AMENDMENTS TO THE DRAWINGS

Application No. 10/693479
Amendment dated January 26, 2006
Reply to Office Action of July 26, 2005

Docket No.: S1022.80434US01

Fig. 1
(PRIOR ART)

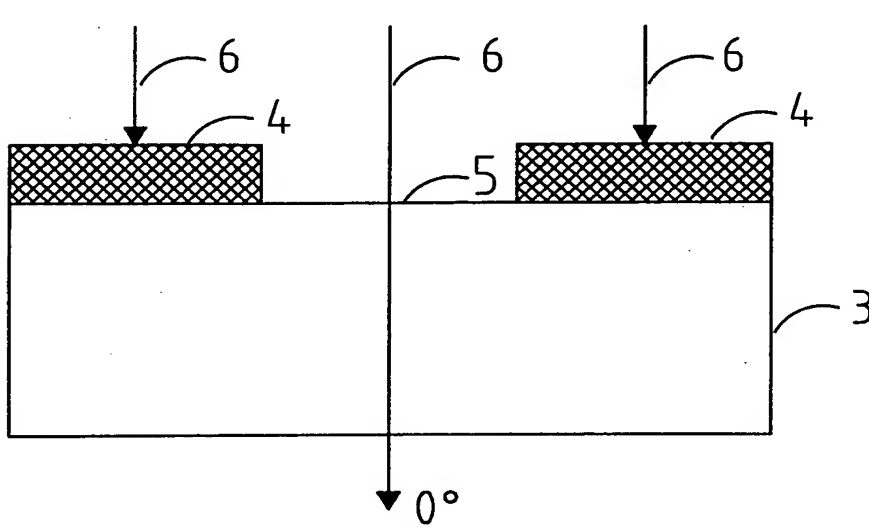
The Office Action noted that Figures 1-5 should be designated by a legend such as -- Prior Art --. This has been done. Review and approval of the proposed drawing correction is respectfully requested.

The Office Action indicates that Figs. 1-5 should be designated by a legend such as --Prior Art--. The drawings have been so corrected. Review and approval of the corrected drawings is respectfully requested.
